4328 Brooklyn Ave NE

Recommendation Meeting

SDCI: 3036008-LU

February 28, 2022

2c,d,e)

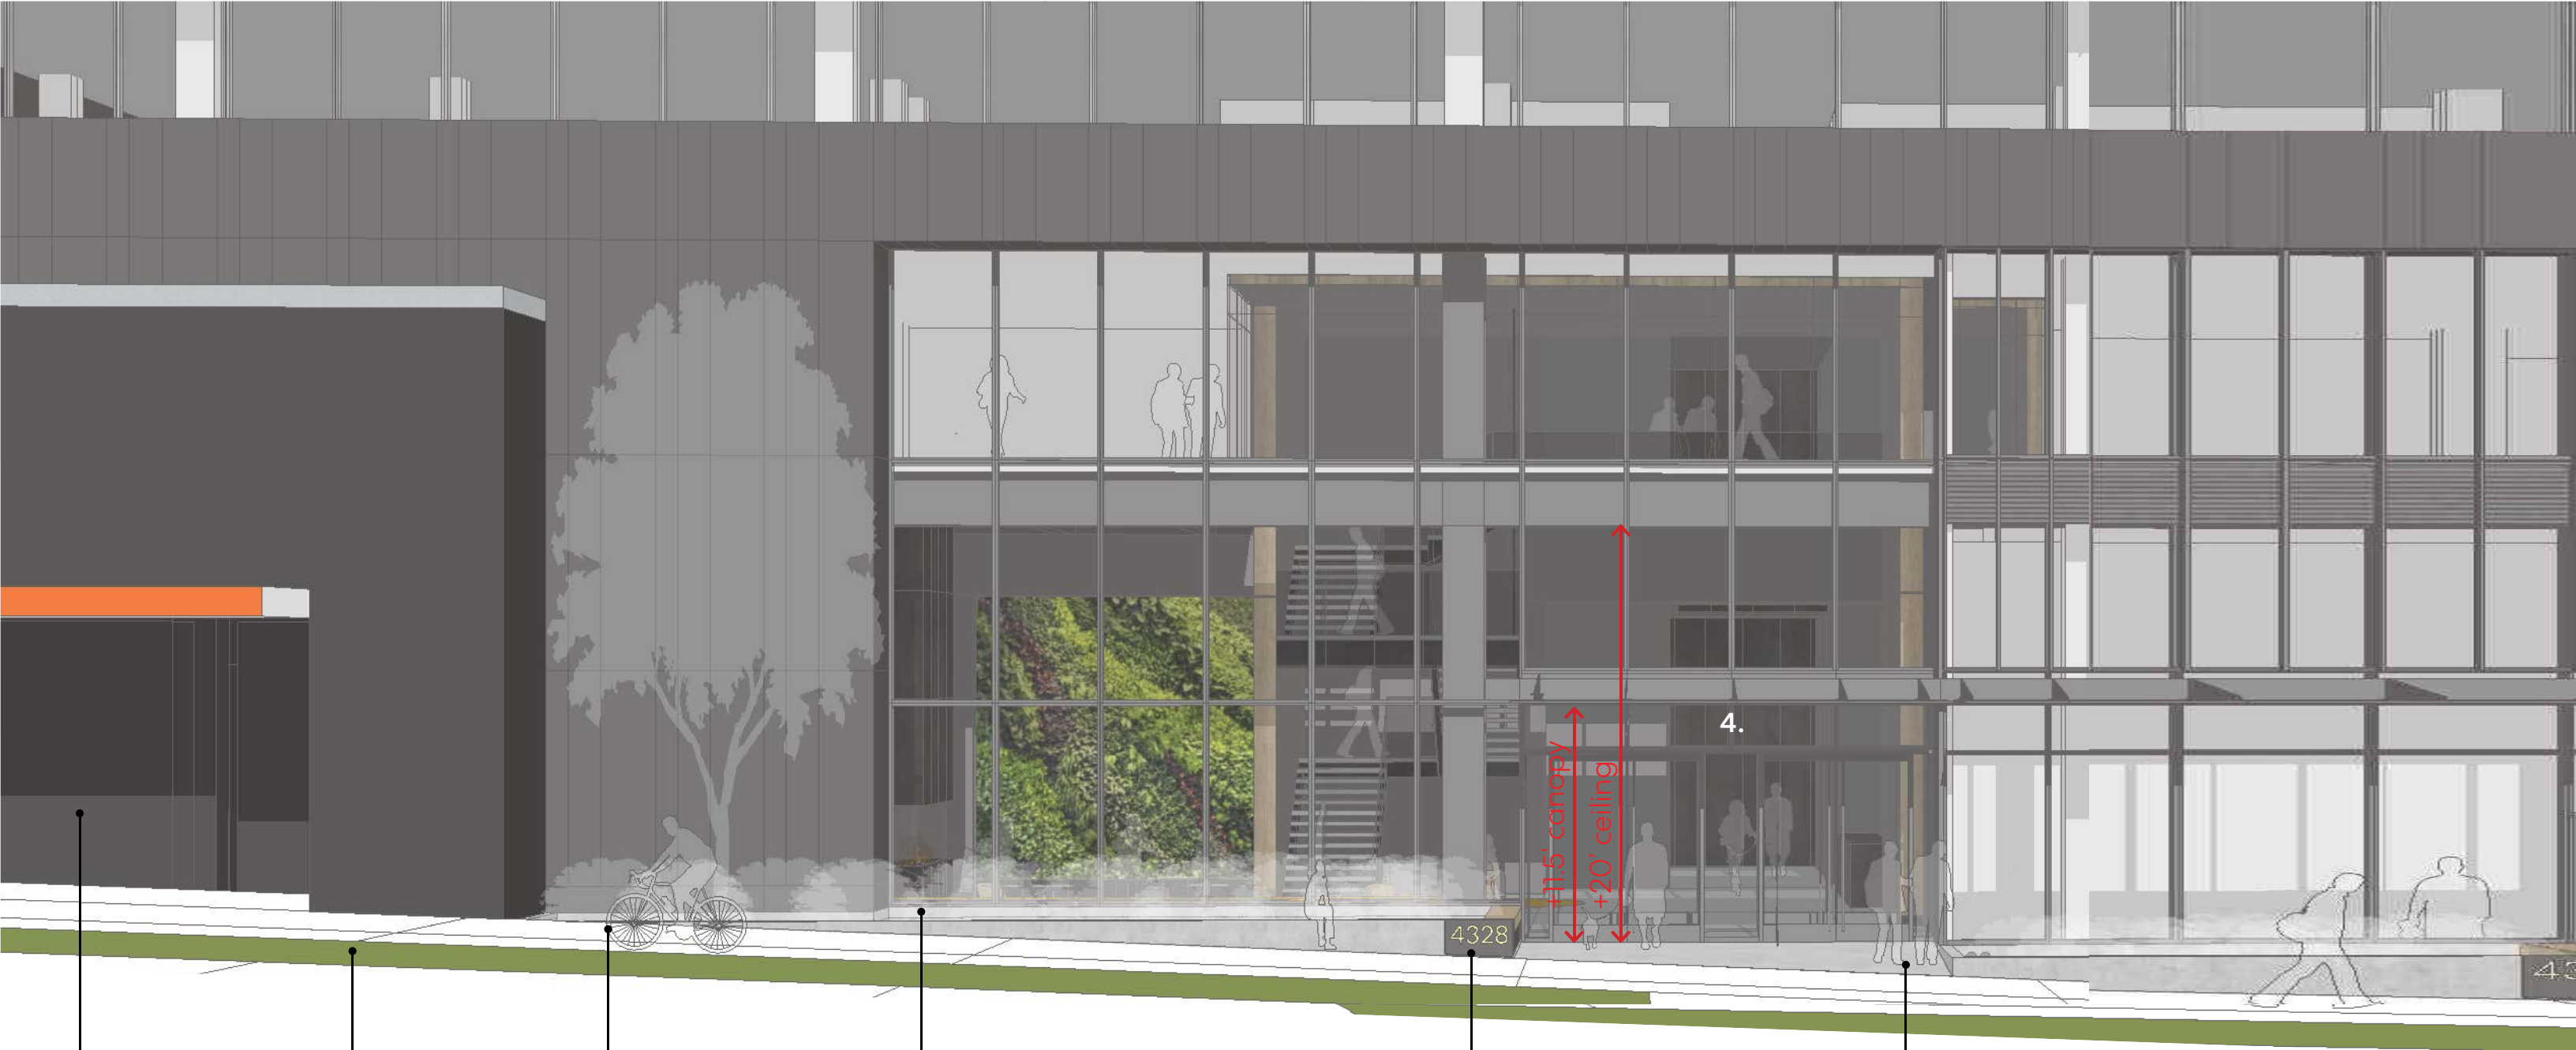
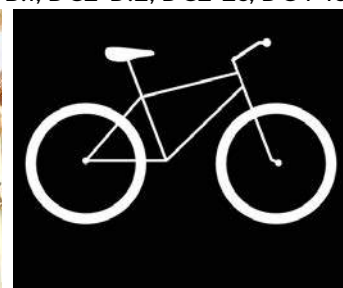
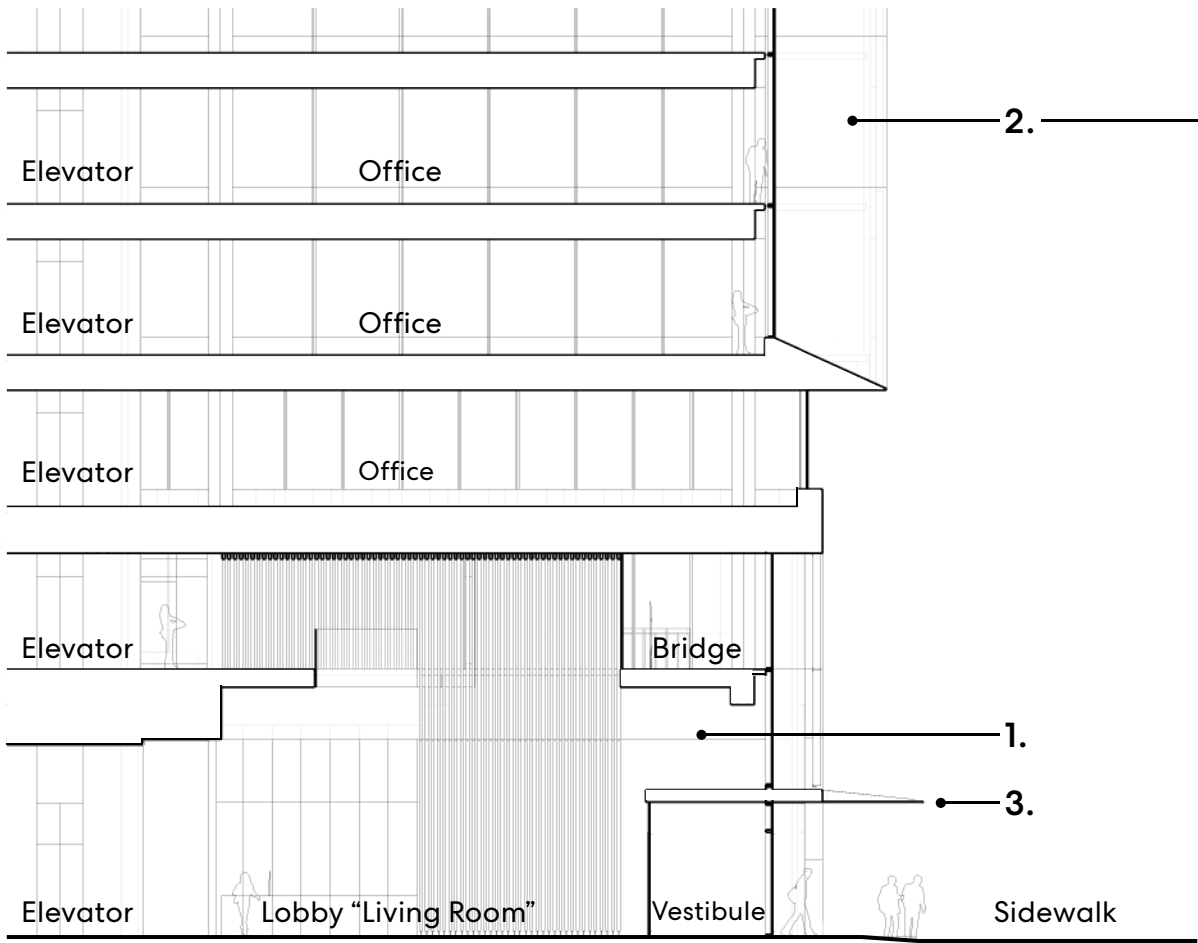
- 2b) *Consider park’s potential uses and users to provide maximal benefit and the best urban design. (see section.03 for landscape design)*
- 2c) *Explore smaller retail modules similar to that along University Ave show how the fabric of the neighborhood informs the fabric of the building and the fabric of the park space*

- 2d) *Study possible bike access and/or visual access to better activate the alley*
- 2e) *Show how retail spaces will encourage activation along Brooklyn Ave*

3. Raised bio-retention planters define the building entries and create an engaging, secondary level of scale along the sidewalk (CS2-2a, PL1-1a, PL3-1a, PL3-C.1, PL3-3b, DC2-1c)

4. Building addressing for street level spaces will be scaled and located for sidewalk level visibility (CS3-1, PL2-D.1, PL3-3b)

2c,e)
The main building lobby and retail areas will be highly visible and prominently located from the mid-street crosswalk connecting with the UW Tower Plaza across Brooklyn Ave NE (CS2-B.2, PL1-1a, PL3-1a, PL3-C.1, PL3-C.2, DC2-1c)

5.
2c,e)
Sidewalk level retail areas and entrances are clearly defined, highly visible, and clustered to optimize single or multi-tenant configurations and for an active streetfront (CS2-A.2, CS2-B.2, CS3-1, PL3-C.1, PL3-C.2, PL3-3a, DC2-1c)

3.
An overhead canopy with vertical fins provides shading, creates a layered facade expression with visual texture, scale, and complexity and establishes a pedestrian scale (DC2-1c, DC2-B.1, DC2-D.2, DC2-2c, DC4-1c)

5.
2d)
Primary access to the bicycle storage facilities is highly visible and provided with signage (CS2-B.2, PL3-C.1, PL3-C.2)

1. The main building entrance, lobby "living room", and retail areas are prominently located to be high visible to pedestrians moving along the sidewalk for an active and vibrant streetfront (CS2-B.2, CS3-1, PL1-1a, PL3-1a, PL3-C.1, PL3-C.2)
2. The tower aperture is aligned to the lobby "living room" creating an overall cohesive architectural expression (DC2-B.1, DC2-2c, DC2-2h, DC4-A.1)
3. An overhead canopy with vertical fins provides shading, creates a layered facade expression with visual texture, scale, and complexity and establishes a pedestrian scale (DC2-B.1, DC2-D.2, DC2-2c, DC4-1c)
4. Bio-retention planters define the building entries and create an engaging pedestrian experience (CS1-D.1, PL1-1a, PL3-C.1, PL3-3b)
